UNITED STATES
NUCLEAR REGULATORY COMMISSION
REGION III
799 ROOSEVELT ROAD
GLEN ELLYN, ILLINOIS 60137

Docket No. 50-483
Docket No. 50-486

IE Bulletin No. 80-20

FAILURES OF WESTINGHOUSE TYPE W-2 SPRING RETURN TO NEUTRAL CONTROL SWITCHES

FIGURE 1:

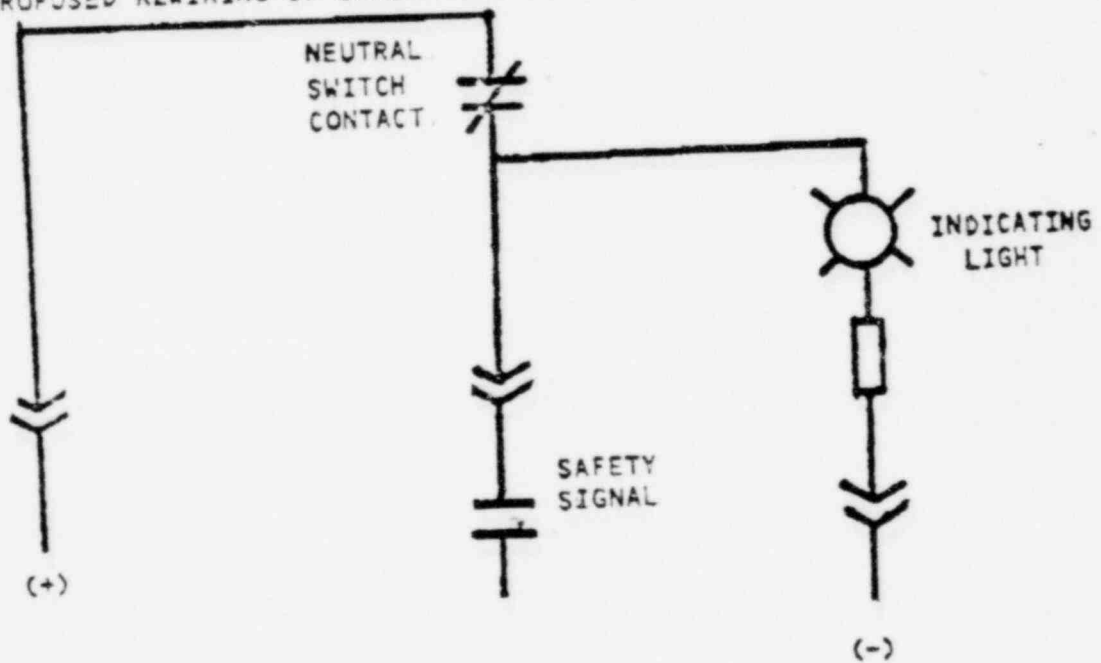
A review of this matter by Westinghouse led to the issuance of NSD Technical Bulletin No. NSD-TB-80-9 to the utility owners of all Westinghouse operating plants. The recommendations contained in the Westinghouse technical bulletin include: (i) testing the neutral position contacts of the subject W-2 switches for continuity, and (ii) rewiring of the indicating light circuit to permit the early detection of a neutral contact failure as shown in Figure 1.

Depending on how the indicating light circuit is wired, loss of continuity thru the neutral position contact of a W-2 switch could remain undetected until the equipment associated with the switch were called upon to operate. Since such a failure would be equivalent to by-passing the system associated with the switch, consideration should be given to rewiring the switches used in safety-related applications as shown in Figure 1. Such rewiring would provide an acceptable means for detecting contact failure, provided the indicating light is in the control room and readily visible by the operator. If the indicating light is not so located, consideration should be given to annunciating the neutral position contact failures at the control room to alert the operator of the inoperable status of a safety-related system. In addition, consideration should be given to adding redundant contacts to the W-2 switches or to replacing the W-2 switches with others having a more positive contact wiping action.

3. Licensees of operating plants and holders of construction permits shall describe the longer term corrective measures planned and the date by which such measures will be implemented by actual installation or by design change, as appropriate. As a minimum, the longer term corrective measures should include rewiring the indicating light as shown in Figure 1 provided the light is readily visible to the control room operator. If not, failures of the neutral position contacts should be annunciated in the control room.

REWIRING OF INDICATING LIGHT CIRCUIT OF W-2 SWITCHES
AS RECOMMENDED BY WESTINGHOUSE TECHNICAL BULLETIN NSD-TB-80-9
